02.00 CONSENTED VS. PROPOSED DRAWINGS
02.07 (NORTH) EAGLE STREET ELEVATION

Planning Application 2020/1350/P

Planning Application 2021/3561/P

02.00 CONSENTED VS. PROPOSED DRAWINGS
02.15 SECTION EE2

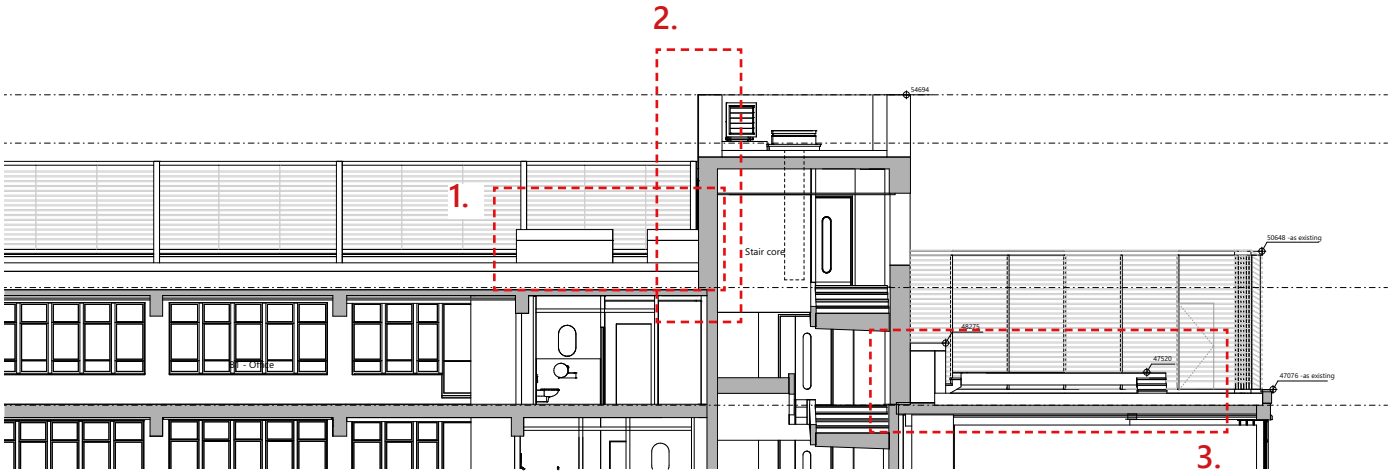
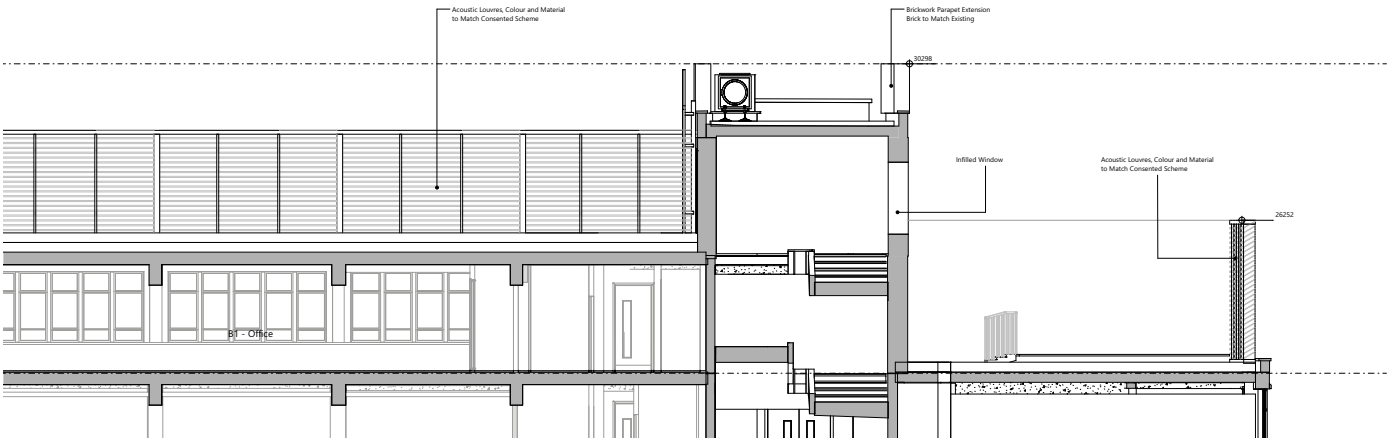
- LINK BLOCK
- 1. Riser up stands configuration amended.
 - 2. CAT ladder omitted. Internal access to core roof through roof hatch on stair enclosure
- EAGLE STREET BLOCK
- 3. Riser up stand height clarified. Plant deck configuration and height amended.
